Re: Croton Overlook
Final Environmental Impact Statement

CROTON OVERLOOK
FINAL ENVIRONMENTAL IMPACT STATEMENT (FEIS)

III. DEIS COMMENTS AND RESPONSES – PUBLIC HEARING, August 2, 2011

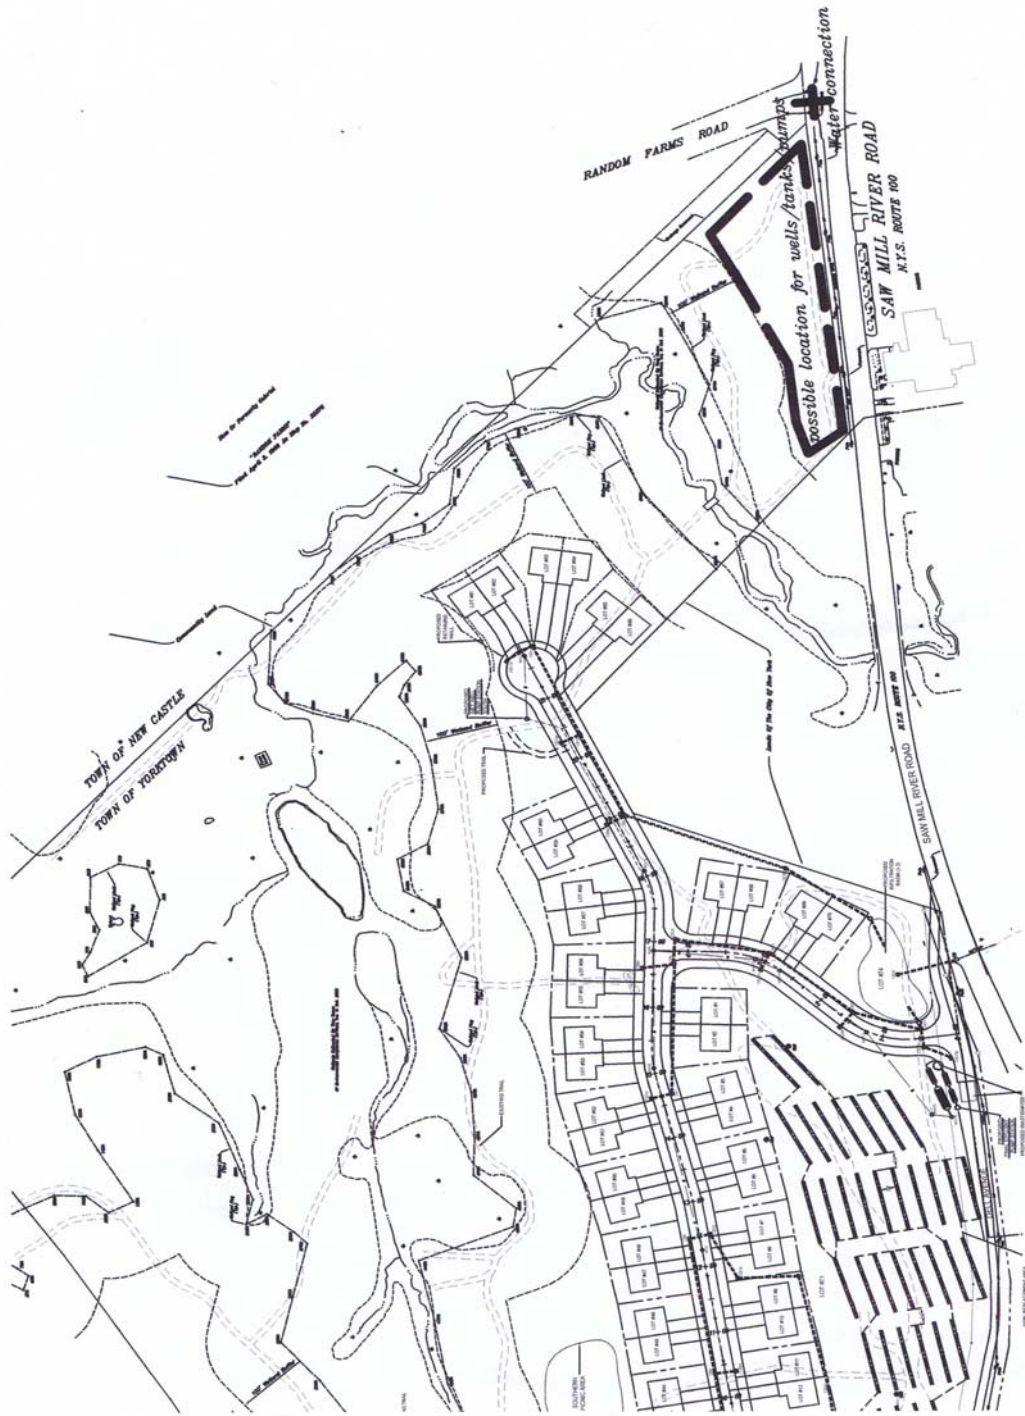
Comment 115 (Planning Department letter, August 30, 2011): Page 186 - First paragraph: Provide detail of potential hydrological impacts to the wetlands if stormwater wetlands are used for irrigation purposes. Has this been considered in the water budget?

Response: *The Applicant indicates stormwater reuse for irrigation will only be employed where practical, and will not have any hydrological impacts to the wetlands. Irrigation requirements will not depend solely on stormwater reuse.*

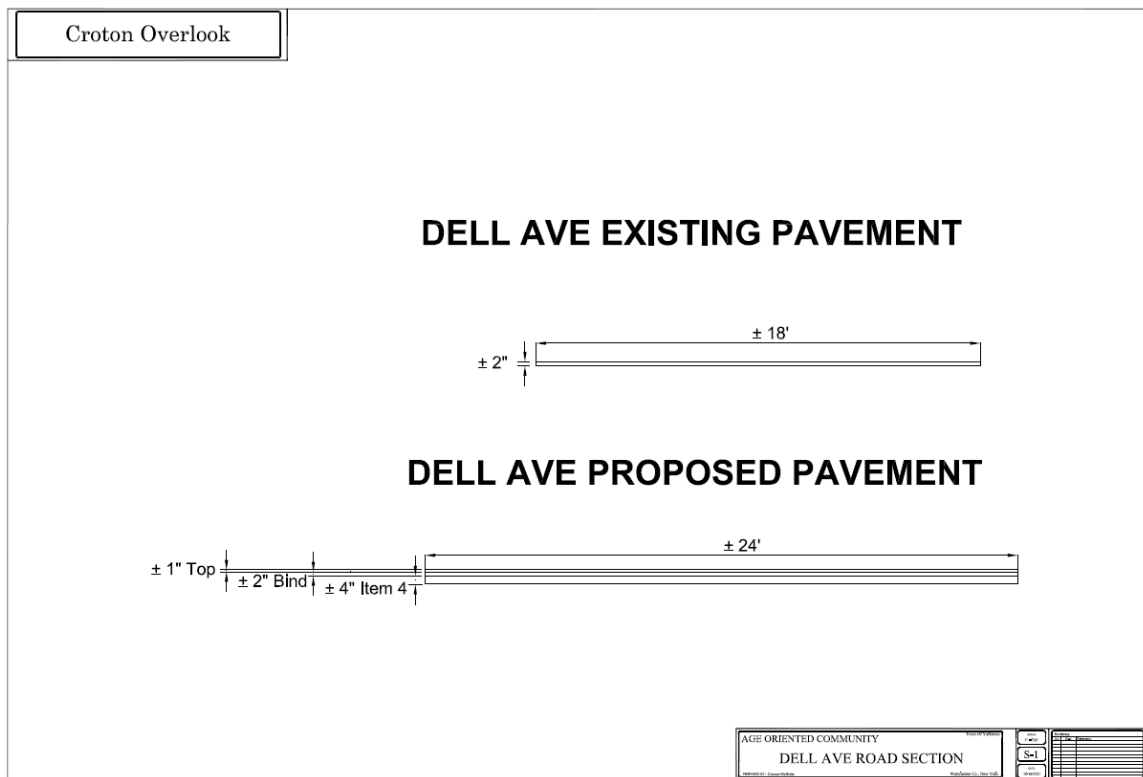
Comment 229 (NYC DEP letter, August 29, 2011): In a letter to the Lead Agency dated March 3, 2001 regarding the scoping documents for this action, DEP requested that interim cut and fill balances, grading plans for each phase of construction and additional information be developed to demonstrate that the plan adequately consider the amount of area necessary to accommodate the work required in each phase of construction and can provide adequate protection.

Response: *The Applicant indicates that the construction sequence, in conjunction with the erosion and sediment control plan, establishes appropriate protective measures to mitigate potential adverse impacts associated with the disturbance of soils. Additional detail will be provided on the final design plans to address specific construction practices.*

The site has been designed to avoid disturbance of soils that are characterized as having steep slopes, and appropriate stabilization measures, including installation of rolled erosion control materials, are proposed for stabilization of any slopes in excess of 3h: 1v.
